Submitted by the RDE IWG

### **Current Status of Development of the Global Technical Regulation on Real Driving Emissions**

The text reproduced below shows the current status of the work to develop a new Global Technical Regulation on Real Driving Emissions. The current version of this draft GTR reflects to a large extent the method and procedure which is already found in the proposed UNR on RDE with changes made in order to make it applicable for more regions. Since the UNR on RDE has been finalised, there is no immediate need to introduce the same methodology at a GTR level. Given this fact, the draft GTR text below has not yet been updated to fully reflect the developments in the UNR. In particular cross-references to other sections need to be updated to reflect the new structure of the GTR – which has been modified to reflect the structure of the UNR RDE. There are also sections of the GTR which would need to be updated, where appropriate, to align with the requirements in UNR RDE. Comments, placeholders and highlighting are used throughout the text to indicate where changes would be needed.

**Figure 3 - Mass definitions**

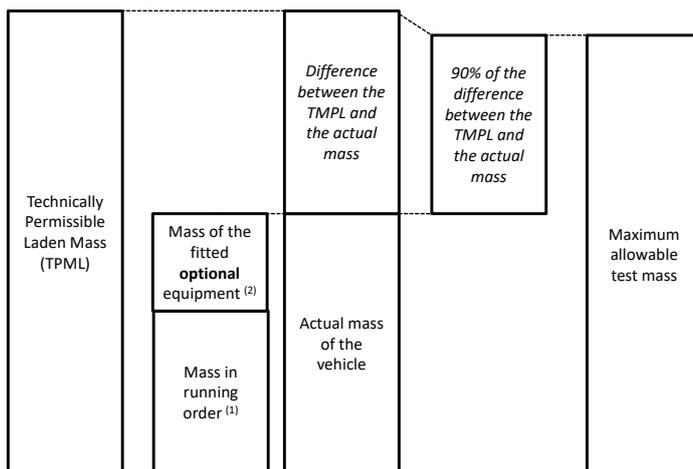
**Commented [RG 1606201]:** NB: Differs from UNR – which needs to be more prescriptive

**Figure 2**

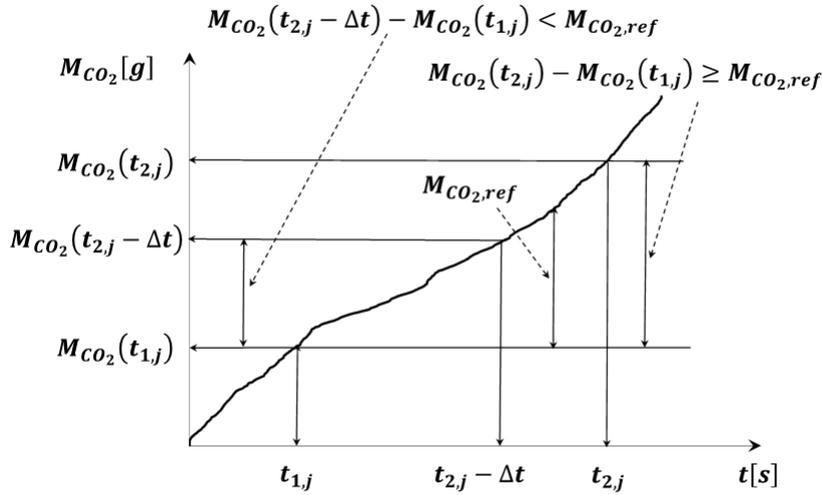
**Commented [RG 16062042]:** The usage of the reference CO<sub>2</sub> mass is illustrated in Figure A8/2. The principle of the calculation is as follows: The RDE distance-specific CO<sub>2</sub> mass emissions are not calculated for the complete data set, but for sub-sets of the complete data set, the length of these sub-sets being determined so as to match always the same fraction of the CO<sub>2</sub> mass emitted by the vehicle over the applicable WLTP test (after all appropriate corrections e.g. ATCT are applied, where relevant). The moving window calculations are conducted with a time increment  $\Delta t$  corresponding to the data sampling frequency. These sub-sets used to calculate the vehicle on-road CO<sub>2</sub> emissions and its average speed are referred to as 'averaging windows' in the following sections. The calculation described in this point shall be run from the first data point (forward), as shown in Figure A8/1.

**Figure 5**

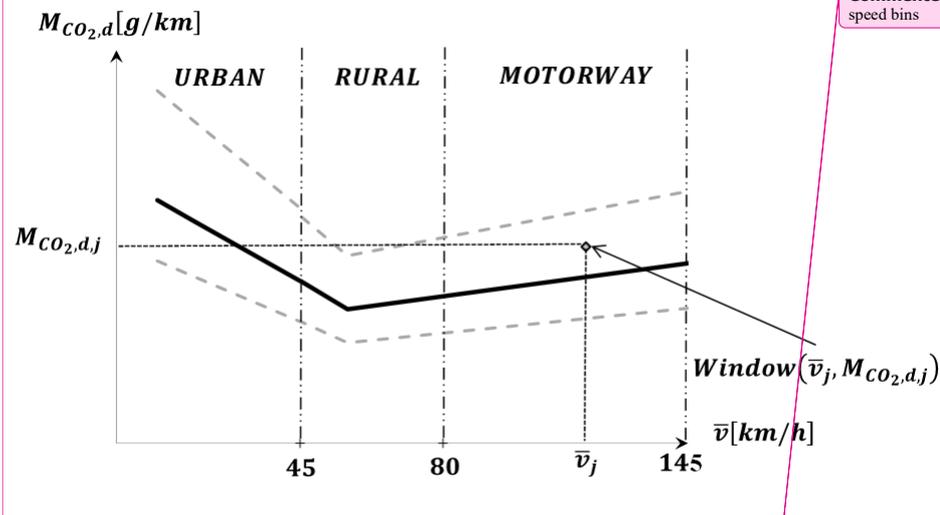
Commented [DP43]: Replace U/R.M, with low, medium high speed bins

Figure 6.

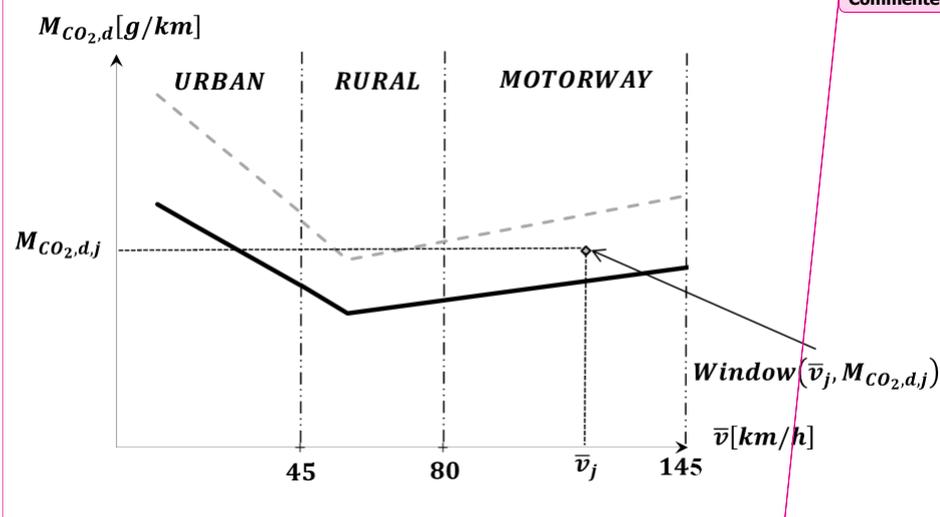
Commented [DP44]: Same here

Figure A11/1

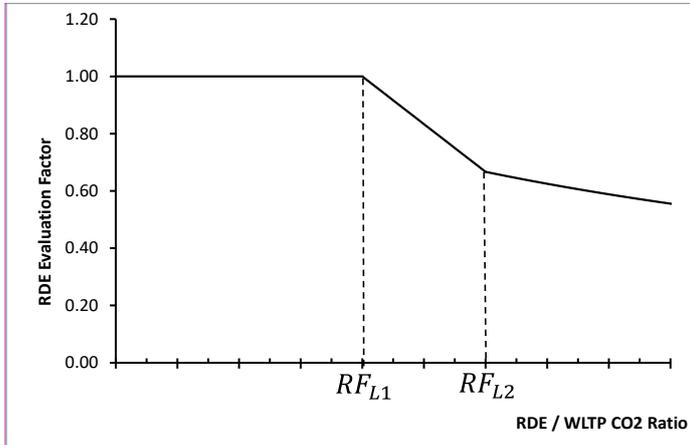
Commented [PB53]: The chart shall be modified to be generic and not specific to WLTP
